The Commission has issued the enclosed Amendment No. 24 to Facility Operating License No. DPR-71 and Amendment No. 48 to Facility Operating License No. DPR-62 for the Brunswick Steam Electric Plant (BSEP), Units Nos. 1 and 2, respectively.

BRUNSWICK STEAM ELECTRIC PLANT, UNIT NO. 1

Amendment No. 24
License No. DPR-71

Amendment No. 48
License No. DPR-62

FIGURE 3.2.1-1

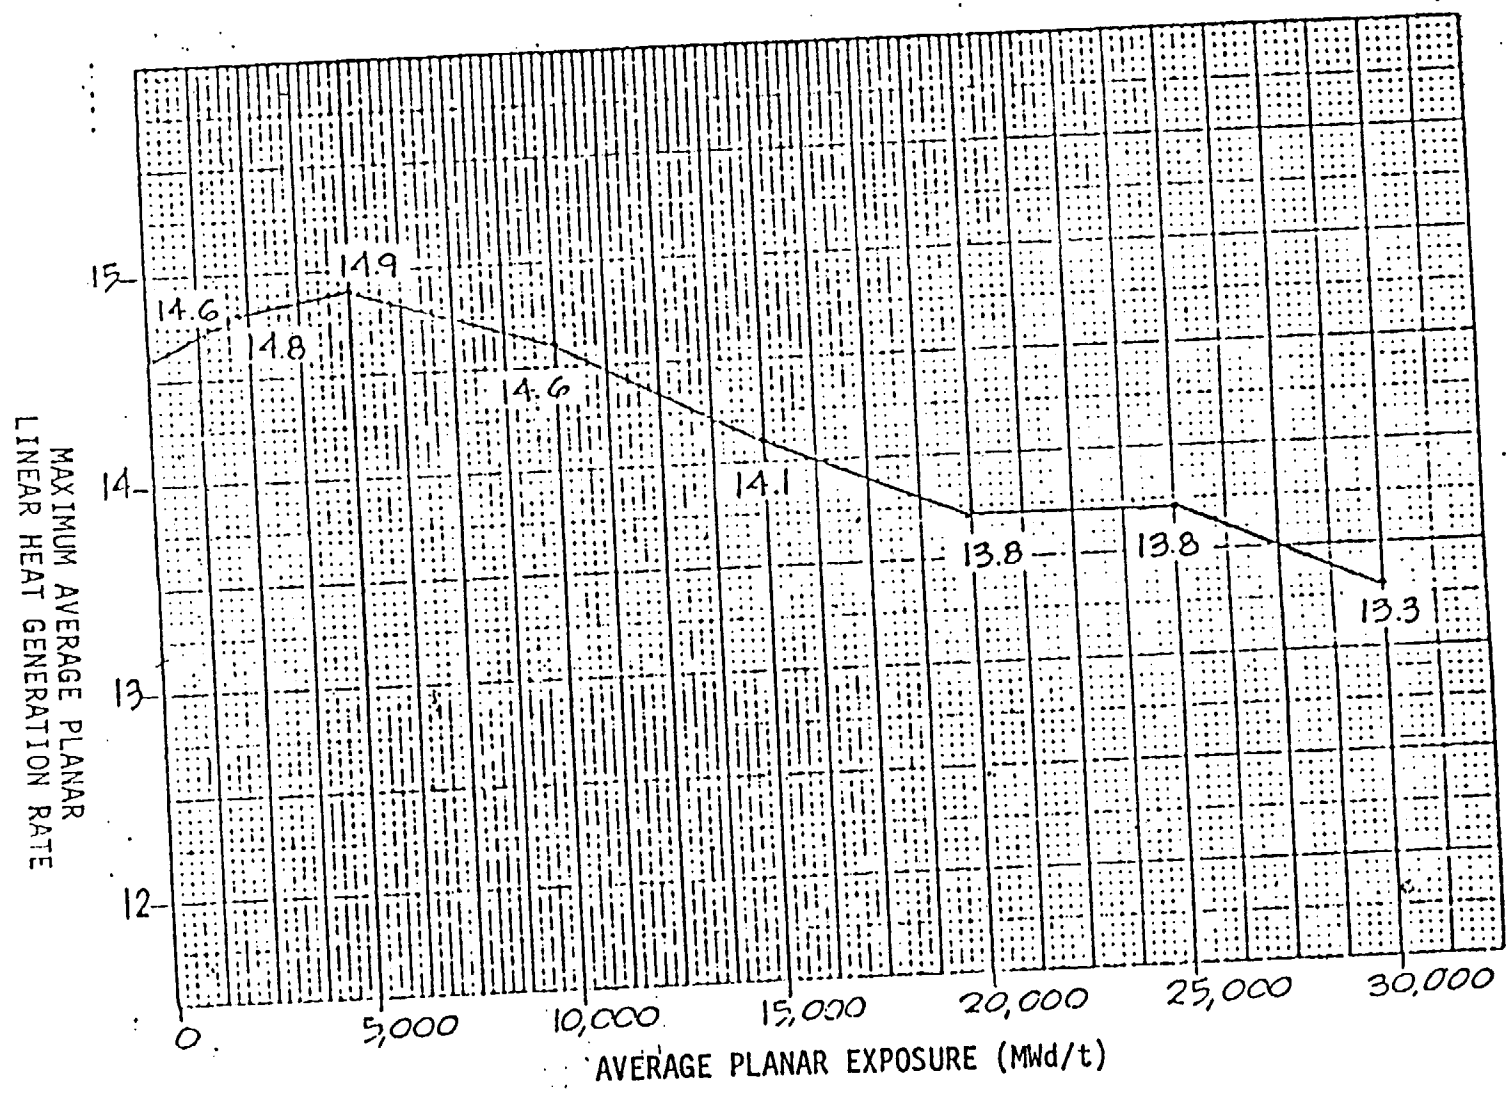
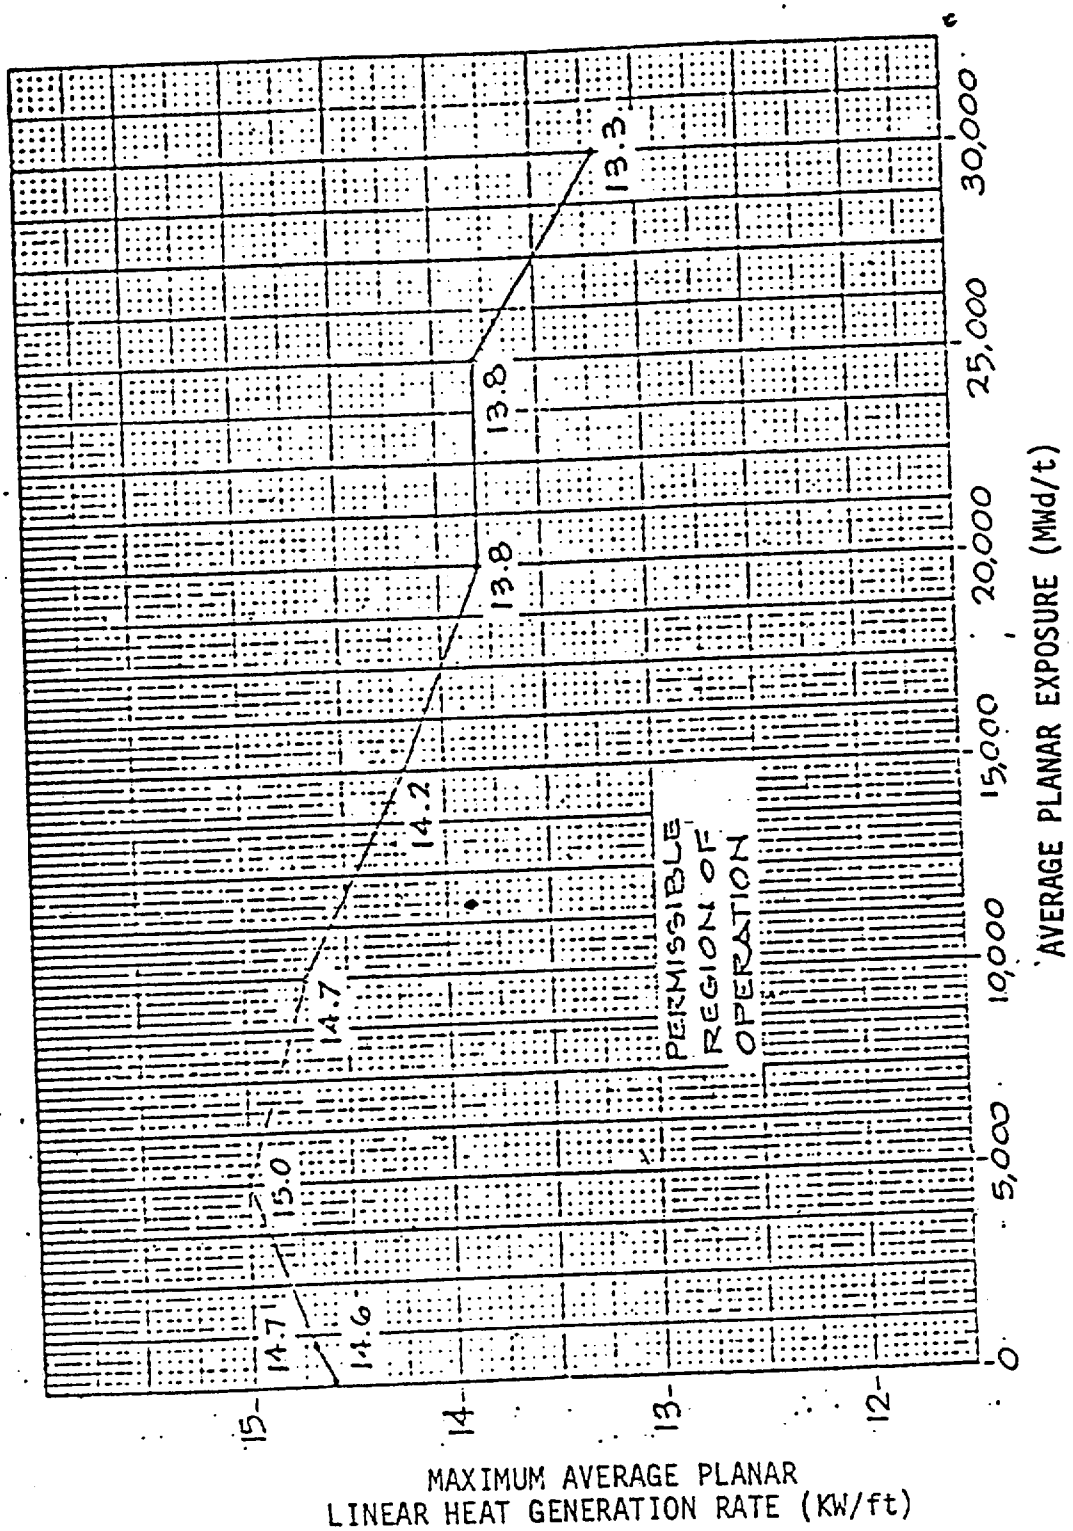
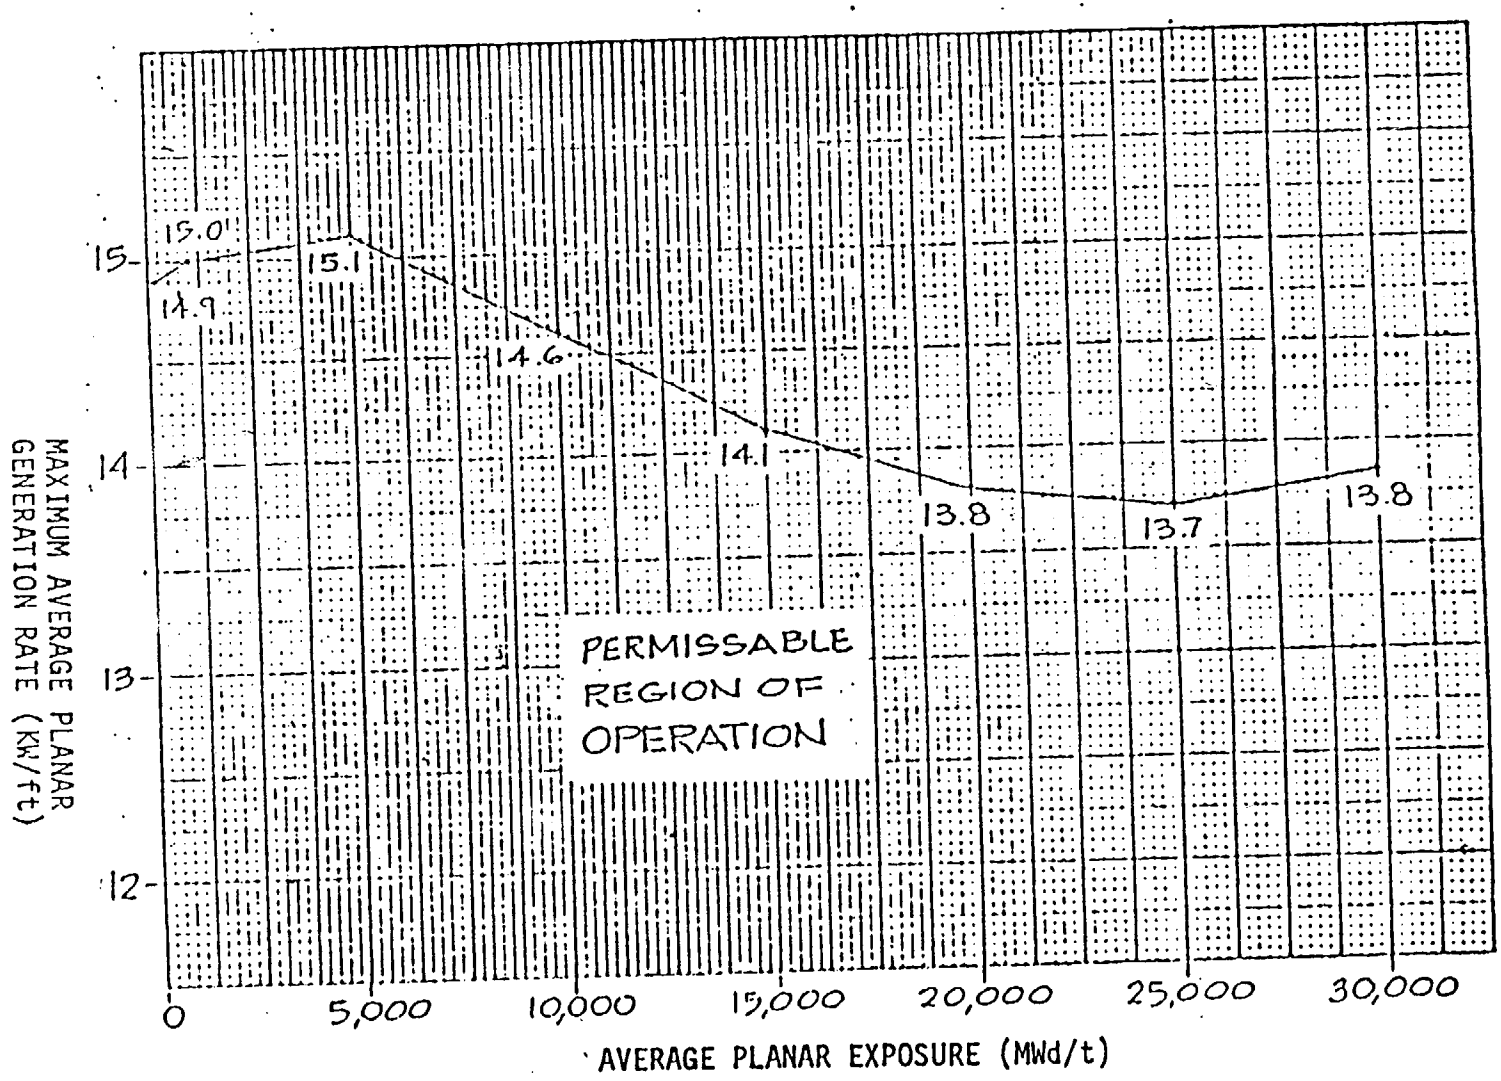
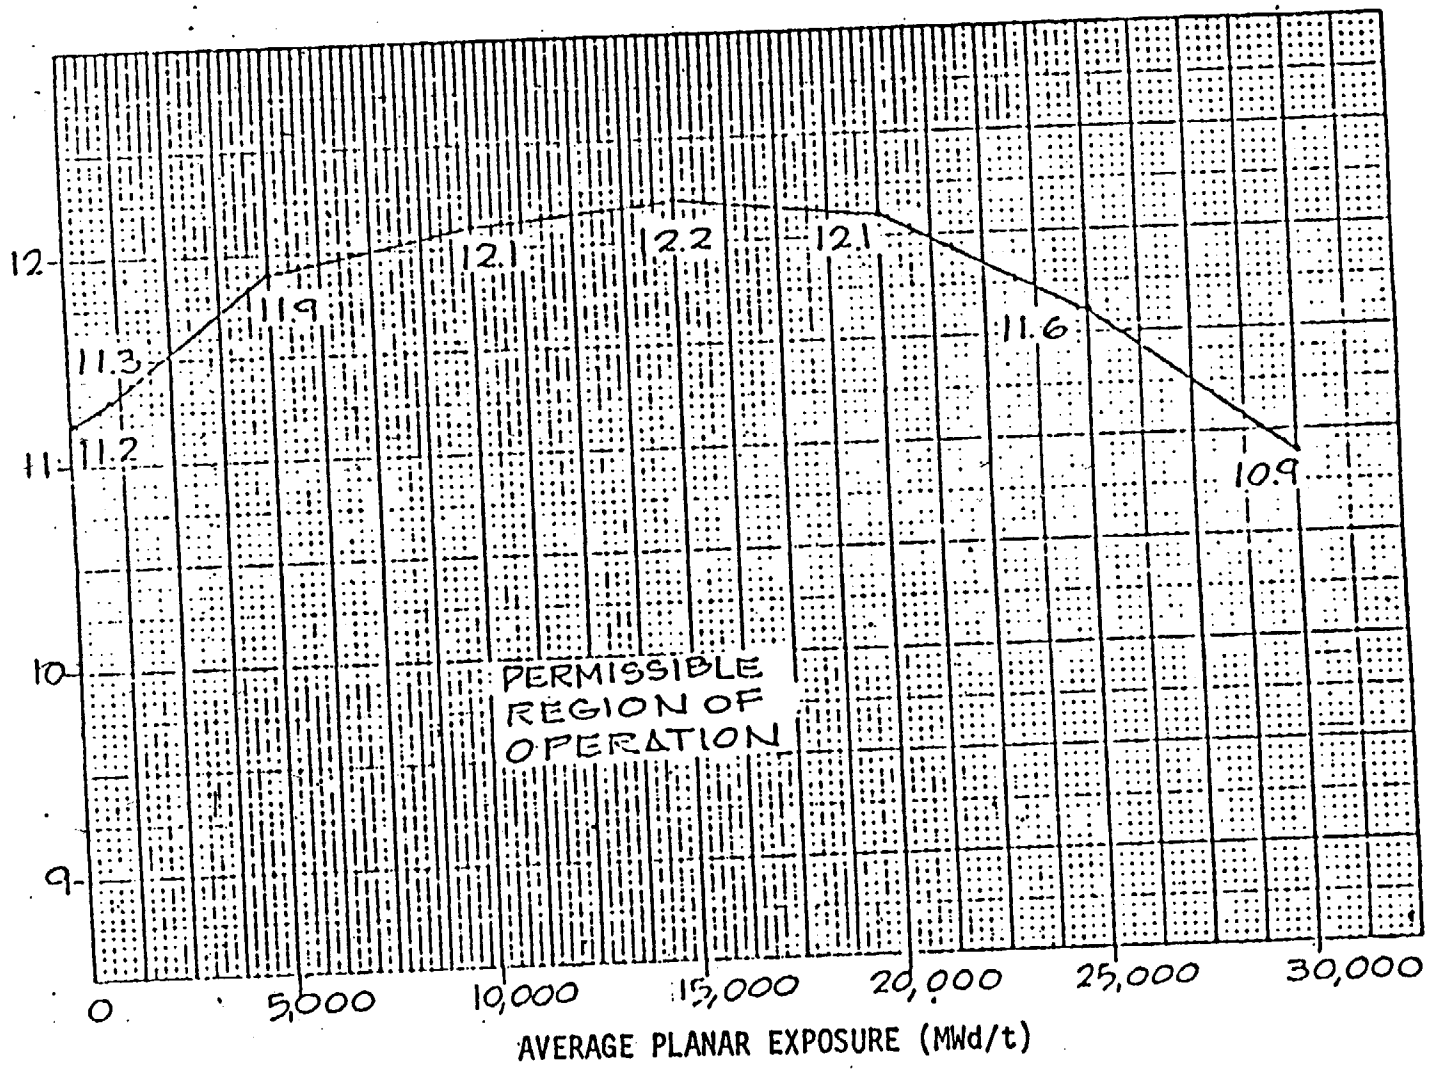
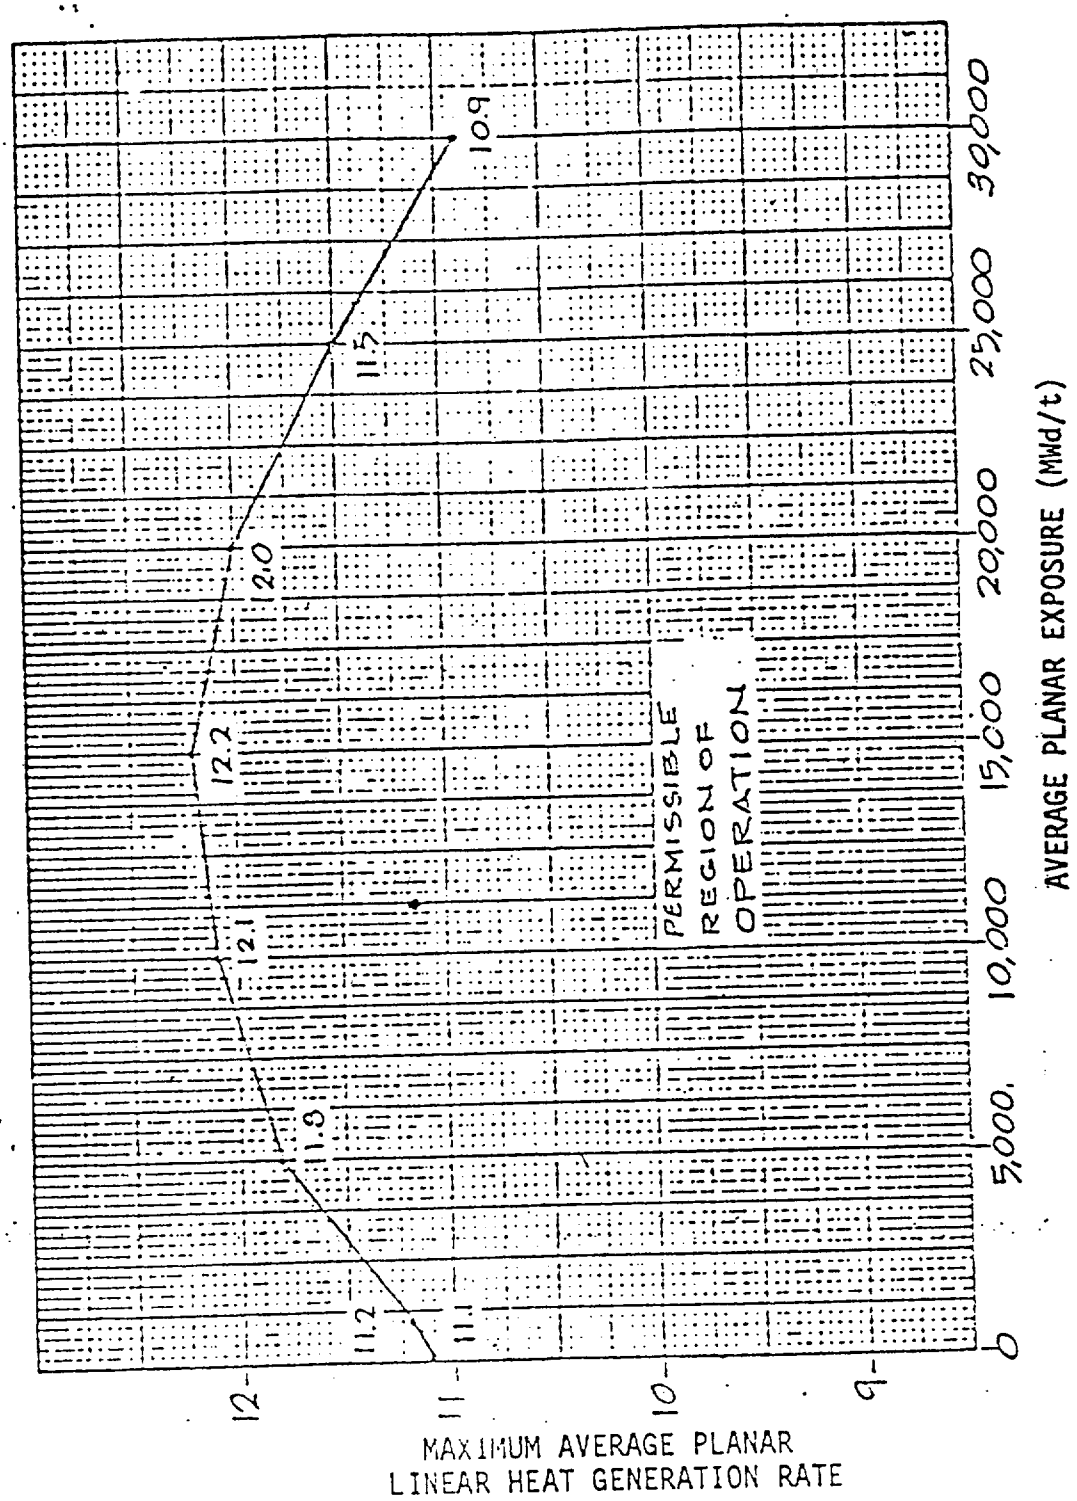
3.2.1 All AVERAGE PLANAR LINEAR HEAT GENERATION RATES (APLHGR's) for each type of fuel as a function of AVERAGE PLANAR EXPOSURE shall not exceed the limits shown in Figures 3.2.1-1, 3.2.1-2, 3.2.1-3, 3.2.1-4, 3.2.1-5, 3.2.1-6 or 3.2.1-7.

We have reviewed the information submitted by the licensee and conclude that all requirements of 10 CFR 50.46 and Appendix K to 10 CFR 50.46 will be met when the reactor is operated in accordance with the MAPLHGR versus Average Planar Exposure values given in Figures 3.2.1-1, 2, 3, 4, 5, 6, and 7 of the Technical Specifications.
